Review of Watermark Coal Project Environmental Impact Statement.

Soils, Rehabilitation Planning and Salinity

Prepared for
SOS Liverpool Plains and Caroonna Coal Action Group

April 2013

Figure 1: Location of Predicted Seepage sites with respect to existing dryland salinity and waterlogging

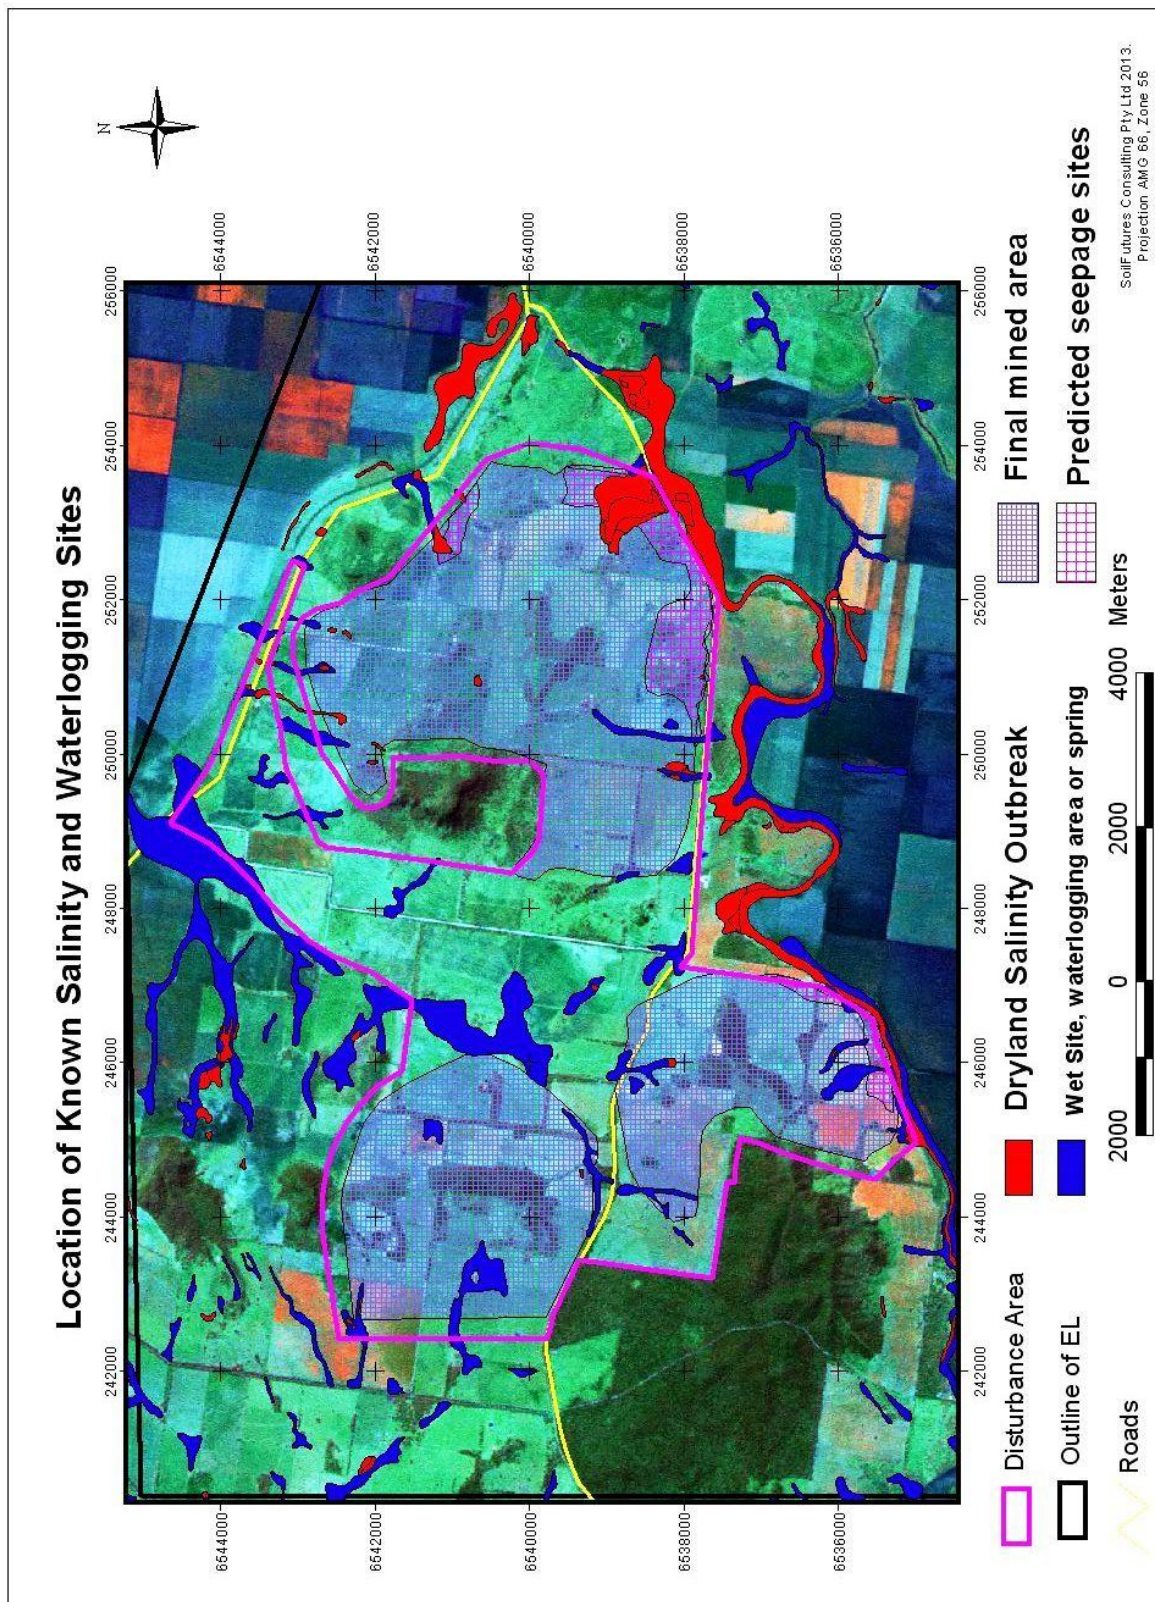
mining induced offsite impacts on stream salinity as pointed out above, in addition to the impacts on existing (or natural) seepages. The Department of Land and Water Conservation had an intensive salinity mapping program, which shows saline outbreaks and waterlogging points in the natural landscape of the Liverpool Plains, largely based on intensive field traverse of sites mapped using aerial photograph interpretation (DLWC 1998). The predicted seepage points induced by mining lie directly adjacent to known salinity outbreaks as shown below in Figure 1.

Native Dog Gully is noted by Mah and Timms (2012) as one of the largest saline seepage “hotspots” in the Namoi Valley. The consequences of additional salt entering the soil and surface runoff systems at these already saline sites is unknown, and no serious discussion

about this is presented in the EIS. As pointed out above, the Namoi Catchment is a major contributor to salt loads in the Murray Darling Basin and has a serious responsibility to reduce salt loads into the system to sustain downstream communities (MDBC, 2005). Consideration needs to be given to existing saline outbreaks with regard to the placement of potential saline seepages. The proximity of Native Dog Gully to the western mining area seepages will ensure that salts enter surface waters during high flow events, exacerbating salt loading of the Mooki River as discussed above.

Figure 2: Estimated runoff from lands to be mined, pre mining

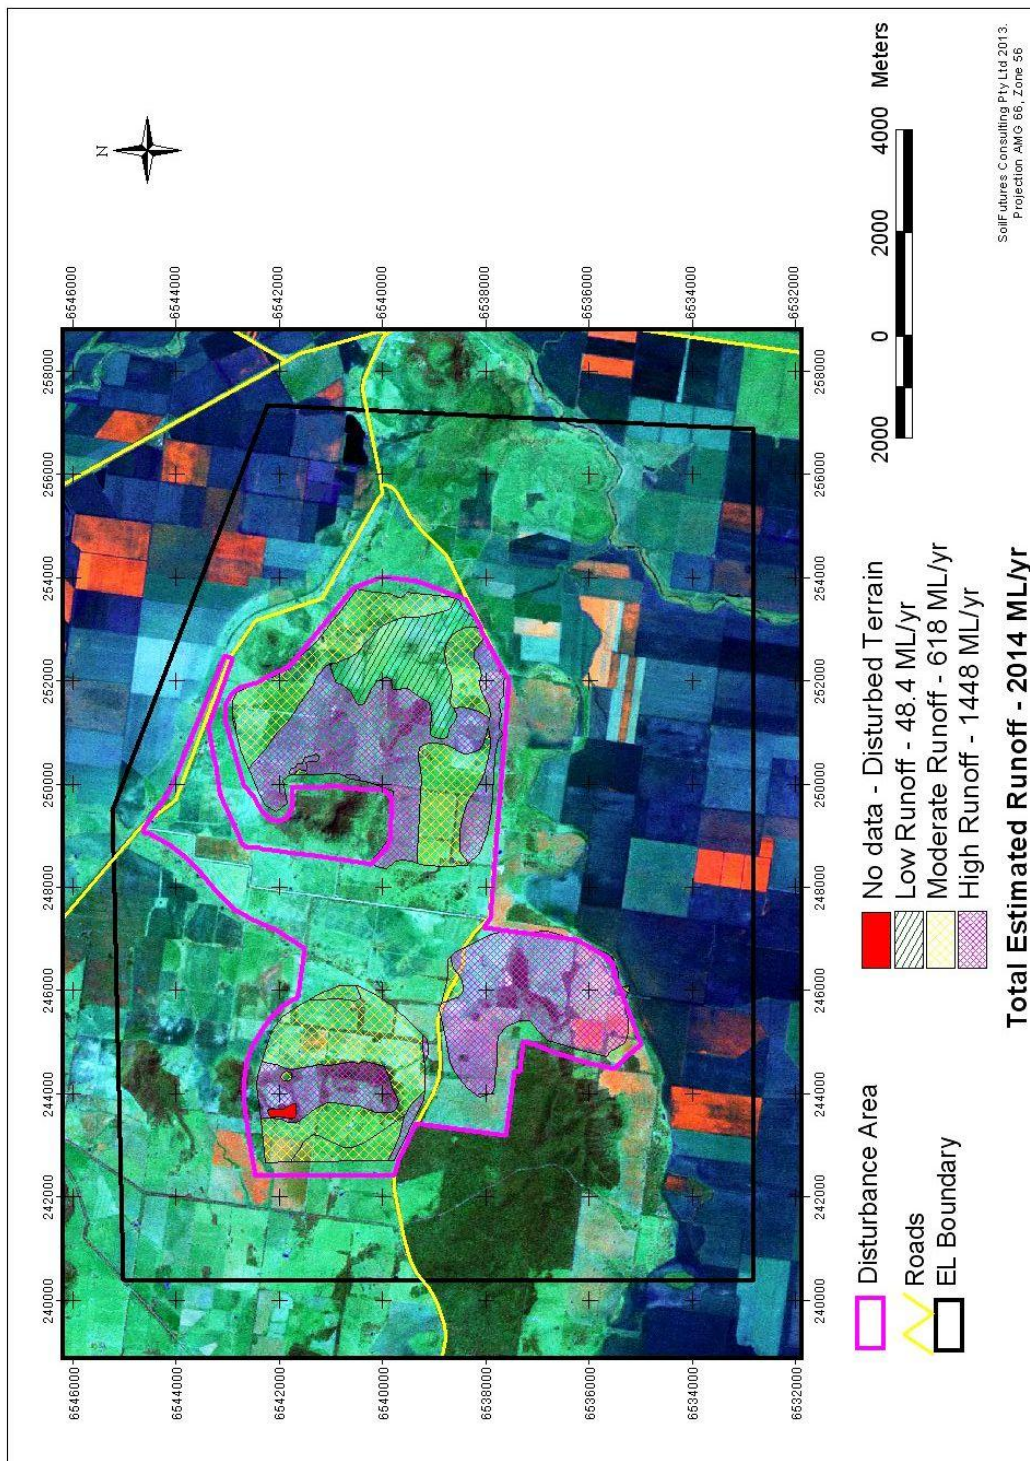
Figure 2 shows an estimated change in natural runoff of 2014ML per year, post mining. No attempt has been made to use the soil information provided in the Soils section of the EIS to use this value as a check on other calculations made for the Project. Figure 3 shows an estimated removal of 552ML natural deep drainage from groundwater systems of the project area post mining. Recharge rates will be higher in the rehabilitated areas as proposed in the EIS, and the fate of these waters appears to be in the form of seepages and input to the final void.
